PROJECT REFERENCE NO. <b>R-5021</b>	SHEET NO. <b>UC-83</b>
DESIGNED BY: <b>MEP</b>	
DRAWN BY: <b>MEP</b>	
CHECKED BY: <b>BMB</b>	
APPROVED BY: <b>BMB</b>	
REVISED:	NORTH CAROLINA DEPARTMENT OF TRANSPORTATION UTILITIES ENGINEERING SEC. PHONE: (919) 707-6690 FAX: (919) 250-4151
UTILITY CONSTRUCTION PLANS ONLY

### UTILITY CONSTRUCTION

DOCUMENT NOT CONSIDERED FINAL UNLESS ALL SIGNATURES COMPLETED

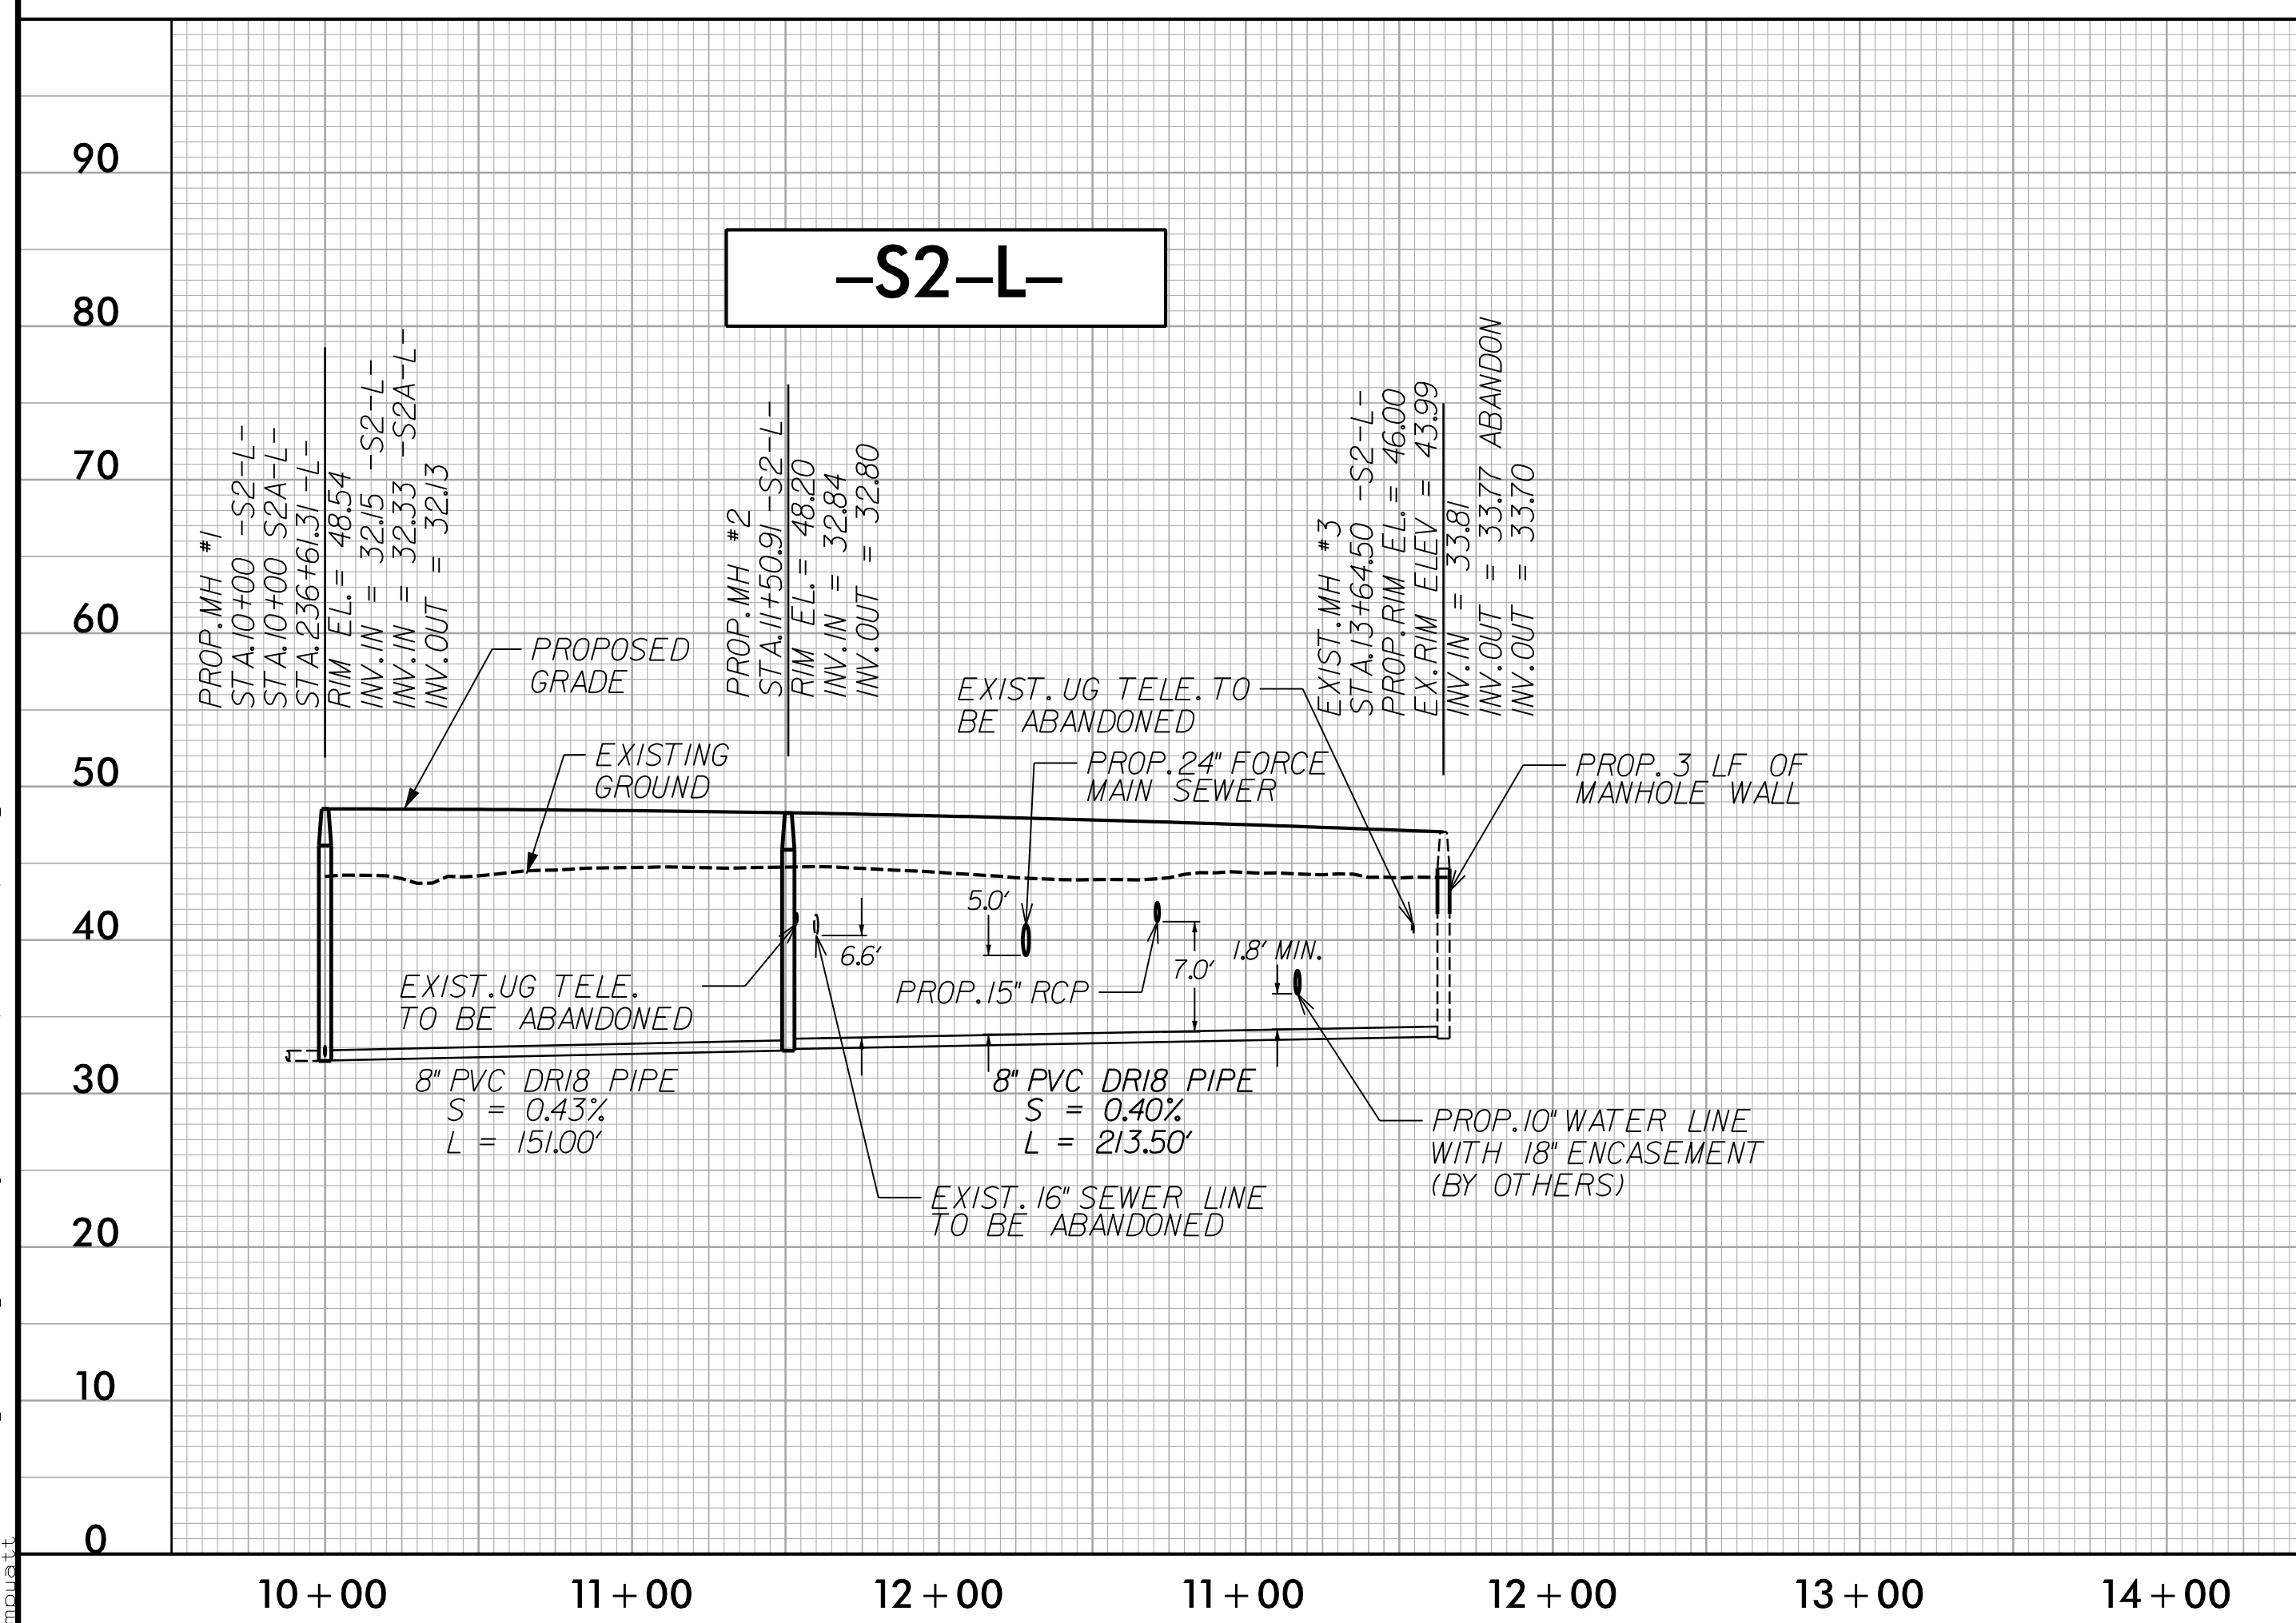
- 1. REMOVED 16" FSS FROM PROFILE
- 2. EXTENDED SEWER PROFILE -S2-L-
- 3. PIPE MATERIAL CHANGE FROM DI PC350 TO PVC DR18 FOR SEWER LINE -S2-L- & -S2A-L-
